**TECHNICAL SERVICE BULLETIN, VIN:
SB-81 Allegro Bus 45 BP, Opening in D/S Wheel Well**

Technical Service Bulletin SB-81 Repair Instructions

Models Involved: 2026 & 2027 45 BP Allegro Bus Motorhomes

Figure 1A - D/S wheel well

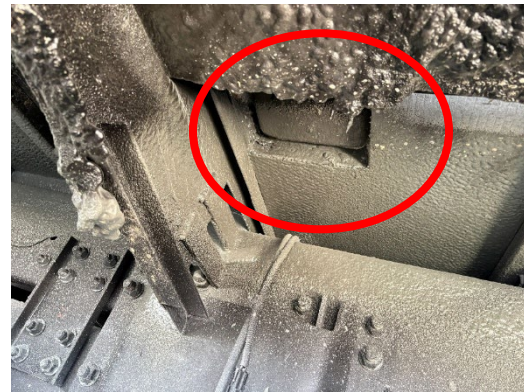
1. Inspect driver's side wheel well. See Figure 1A & 1B.

Figure 1B needs plate installed

2. If there is an opening, proceed with the repair instructions below.

1. Install part #5197384 to cover the hole. Install with at least 6, 1" self-tapping wood screws, but use more if needed. Make sure to install a screw in each corner.
2. Use Quad or Silicon caulk to seal the edges, see Figure 2 for repaired wheel well.
